# Fundamental Issues Regarding 10 CFR 72.48 Implementation and NEI 12-04

**Nuclear Energy Institute**

March 3, 2016 • Rockville, MD

Process for GL Review of CoC Holder 72.48s

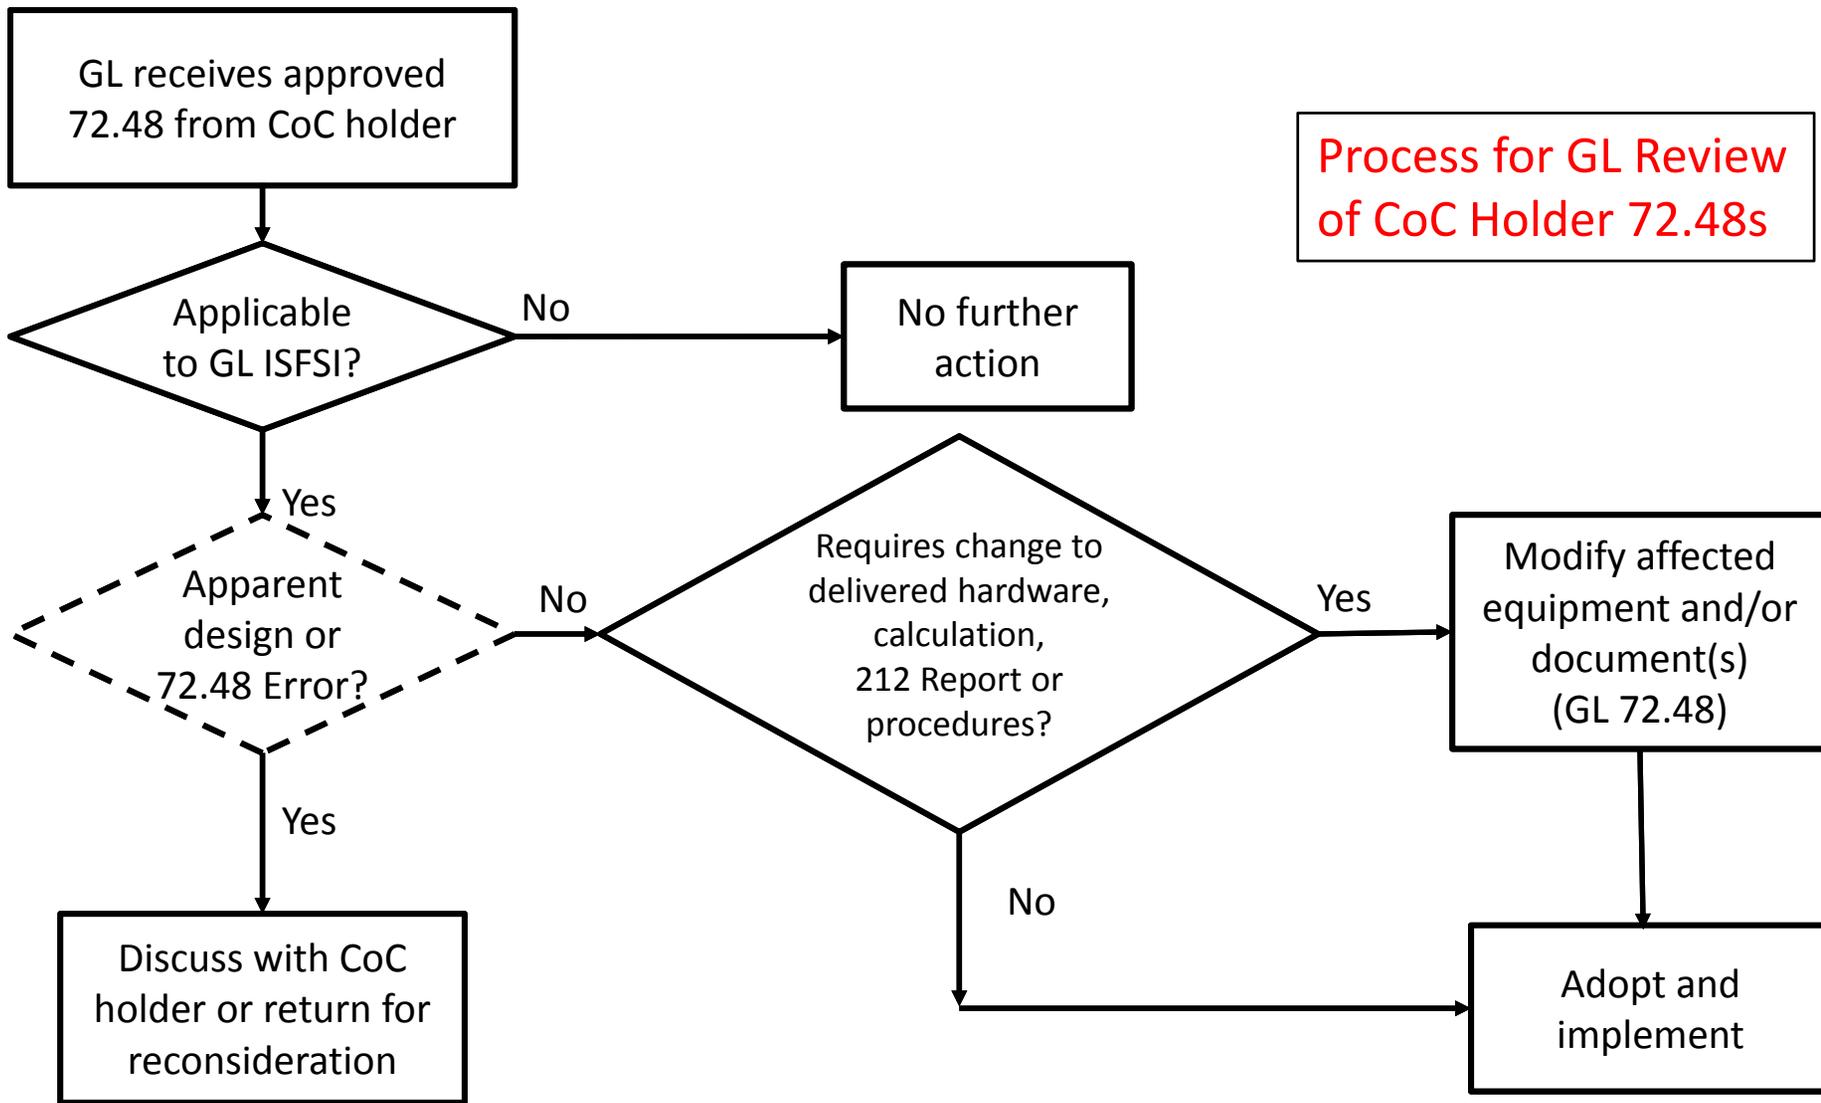
- 10 CFR 72.48 does not address GLs performing a “suitability review”
- GLs do review CoC holder 72.48s and apply their own 72.48 process where required, consistent with the rule and the endorsed guidance
- Some GLs may choose to go farther
- The GL process for handling CoC holder 72.48s is provided on the following figure
